GEOTECHNICAL INVESTIGATION
PROPOSED CAMBRIDGE SCHOOL
SOUTHWEST CORNER OF CAMINO DEL SUR AND COYOTE BUSH DRIVE
SAN DIEGO, CALIFORNIA

Subject: Response to Comments and Geotechnical Addendum
Cambridge School
SW Corner of Camino Del Sur and Coyote Bush Drive, San Diego, California

GEOTECHNICAL EXPLORATION LOCATION MAP
PROPOSED CAMBRIDGE SCHOOL
SW CORNER OF CAMINO DEL SUR & COYOTE BUSH ROAD
SAN DIEGO, CALIFORNIA

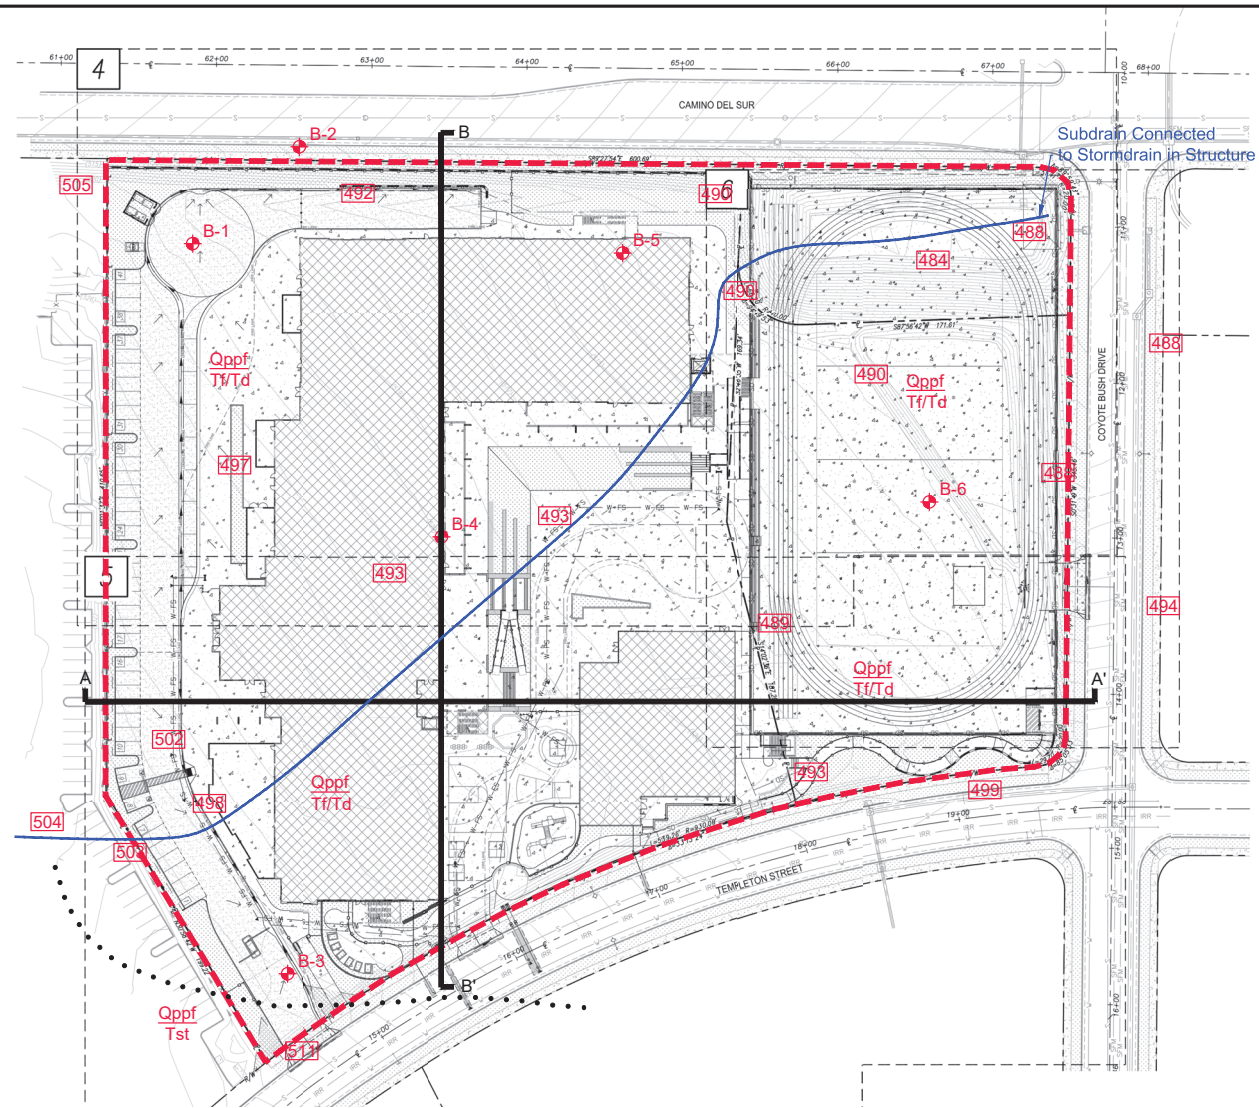
Comment Issue No. 2: The Architect of work must show the limits of grading on the grading plan. The limits of grading must encompass the limits of recommended remedial grading provided by the project's geotechnical consultant. This must be delineated on the plans with a call out and or symbol.

Comment Issue No. 13: Please provide an updated geologic map showing fill and geology. If remedial grading is recommended, show the limits of the recommended remedial grading on the geotechnical map. Please include the limits of grading provided by the Geocon’s As-graded report and delineate areas/removals of alluvium/colluvium. Please include locations of cross sections. Note, the geotechnical consultant should determine if the limits of grading may impact environmental resources on the site.

Response: UES has prepared the attached Figure 2 Geotechnical Exploration Location Map, based on the preliminary grading plans issued by Spear & Associates (2023) for the project. Figure 2 shows the anticipated limits of remedial grading, which coincide with the approximate property line.

Response: UES has prepared Figure 2, Geotechnical Exploration Location Map including the requested information. As described in the response to Comment 7, Geocon (2014) indicated that compressible alluvium/colluvium has been removed from the proposed development area. UES does not anticipate that the limits of grading will impact environmental resources on the site. However, UES has not addressed the proposed development for the purposes of environmental review, which is not within UES’s scope of work for the project.

GEOLOGIC CROSS SECTION
PROPOSED CAMBRIDGE SCHOOL
SW CORNER OF CAMINO DEL SUR & COYOTE BUSH ROAD
SAN DIEGO, CALIFORNIA

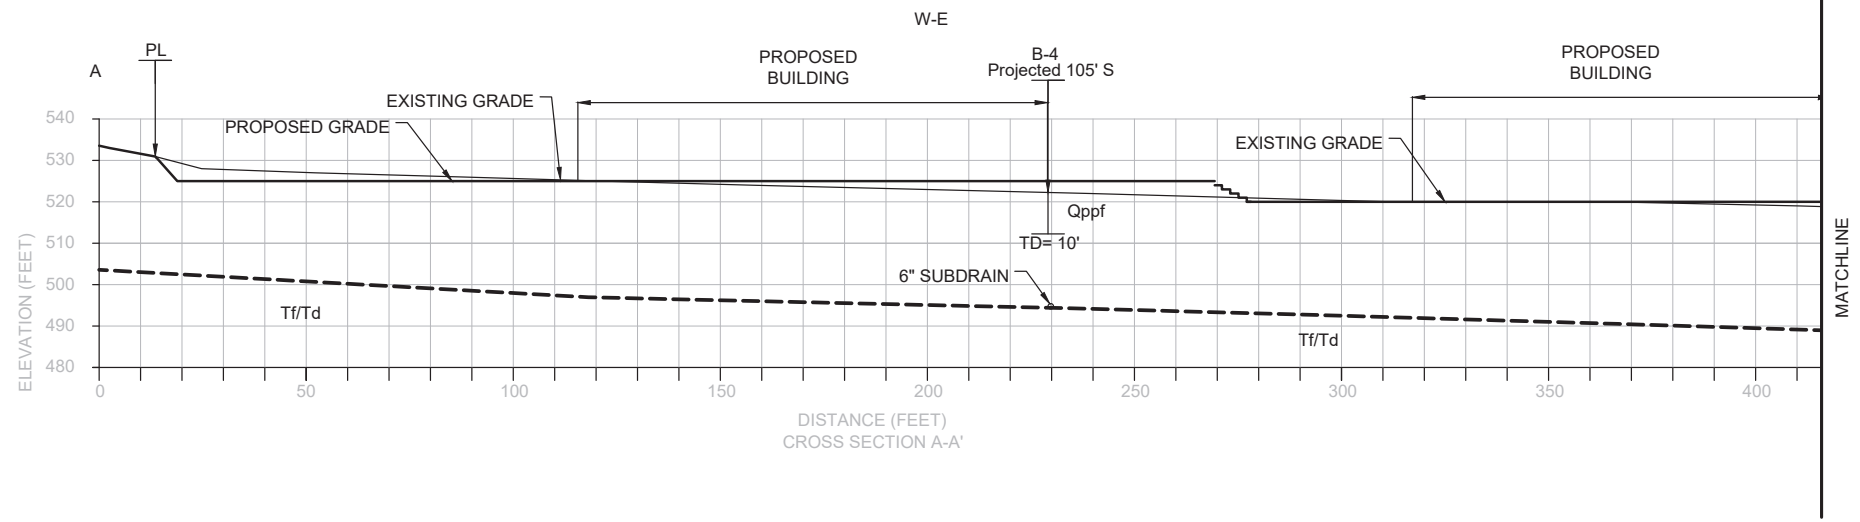
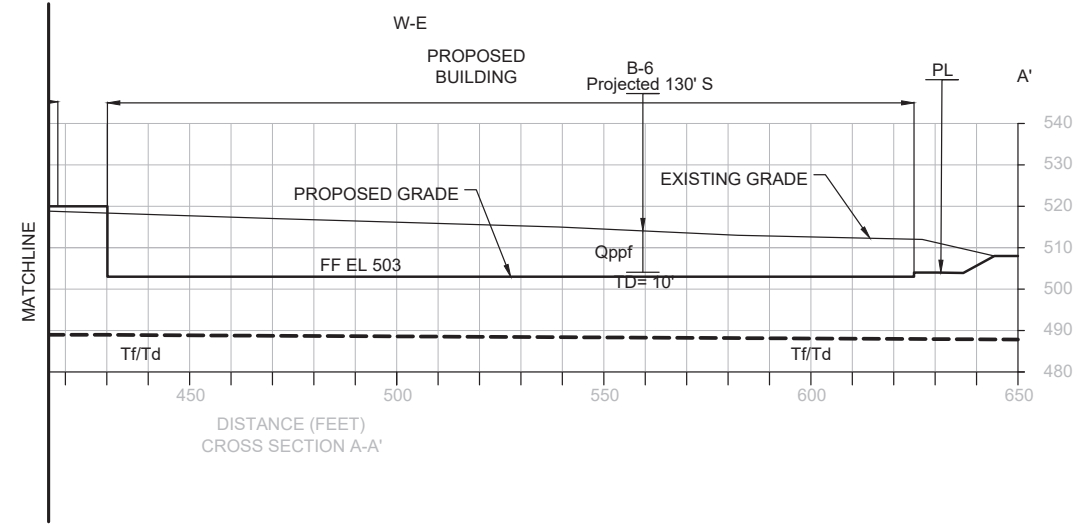
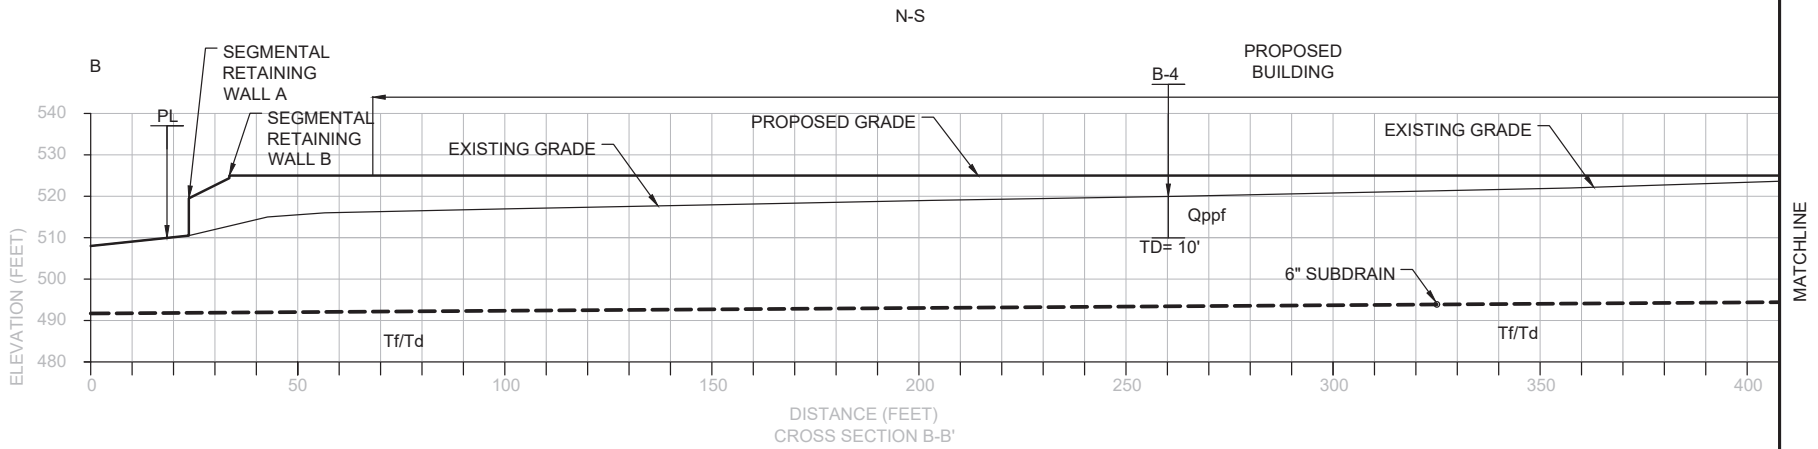
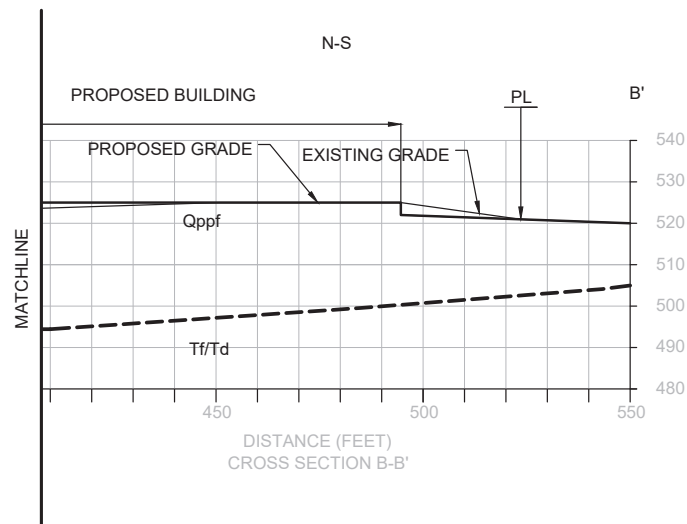
Comment Issue No. 12: Please provide two representative geologic/ geotechnical cross sections that show the existing and proposed grades, the distribution of fill and geologic units. Show the anticipated area of recommended remedial grading, including temporary slopes (if applicable). (approx. N-S & E-W).

Response: UES has prepared Figures 2A and 2B showing two representative geologic/geotechnical cross sections A-A’ and B-B’ (approx. W-E & N-S), including the requested information at the locations shown in Figure 2.
